Access Compliance Report

Public Rights-of-Way

(Curb Ramps)

Intersection ID: 52716	Main Street: AGAVA_LN	Cross Street: MAIDENHAIR_CT	Location: SW
ADA ID: C635255F046D	Ramp Type: Perp	Initial Pass/Fail: Pass	Overall Compliance: No
Severity Score: 0			
Codes/Mitigation Info/Possible Solution		Field Measurements/Component Compliance

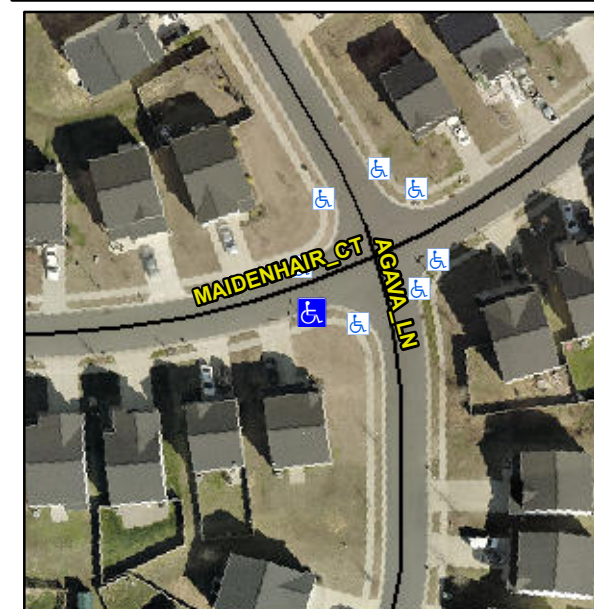
Not Found, R304.2.1

Possible Solutions:

Remove & Replace Entire Ramp.
